# Access Compliance Report

## Public Rights-of-Way

### (Curb Ramps)

Intersection ID: 48884	Main Street: REINBECK_DR	Cross Street: OLD_POTTERS_RD	Location: W
ADA ID: 8168C5652B7A	Ramp Type: Perp	Initial Pass/Fail: Fail	Overall Compliance: No
Severity Score: 22.5			
Codes/Mitigation Info/Possible Solution		Field Measurements/Component Compliance

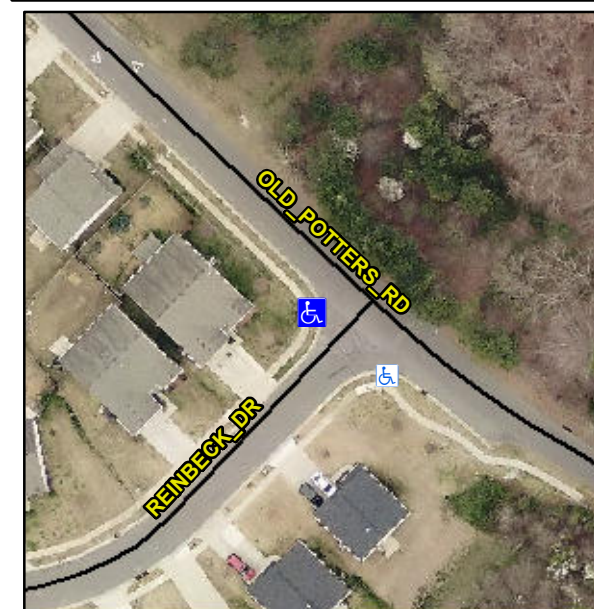
**Not Found, R304.5.1, R304.2.2, R304.5.3**

Compliance	Description	Data	Compliance	Description	Data
N/A	Ramp Length (in)	48.0	No	Ramp Slope (%)	9.8
No	Ramp Width (in)	47.5	No	Ramp XSlope (%)	3.9
N/A	Flare Type LT	N/A	N/A	Flare Type RT	N/A
N/A	Flare Slope LT (%)	N/A	N/A	Flare Slope RT (%)	N/A
N/A	Flare Traversable LT?	N/A	N/A	Flare Traversable RT?	N/A
N/A	Landing Length (in)	N/A	N/A	DWS Provided?	N/A
N/A	Landing Width (in)	N/A	N/A	DWS Contrast?	N/A
N/A	Landing Slope (%)	N/A	N/A	DWS Length (in)	N/A
N/A	Landing X Slope (%)	N/A	N/A	DWS Full Width?	N/A
N/A	Landing Curb? (Y/N)	N/A	N/A	DWS Offset (in)	N/A
N/A	Shared Landing?	N/A			
N/A	Gutter Ponding?	N/A	N/A	Gutter Slope (%)	N/A
N/A	Gutter Lip Ht (in)	N/A	N/A	Gutter X Slope (%)	N/A
N/A	Painted X Walk1?	No	N/A	Painted X Walk2?	N/A
	X Walk 1 Direction	To SE		X Walk 2 Direction	N/A
N/A	X Walk 1 Width (in)	N/A	N/A	X Walk 2 Width (in)	N/A
	X Walk 1 Slope (%)	1.6		X Walk 2 Slope (%)	N/A
	X Walk 1 X Slope (%)	1.8		X Walk 2 X Slope (%)	N/A

**Remove & Replace Entire Ramp.**
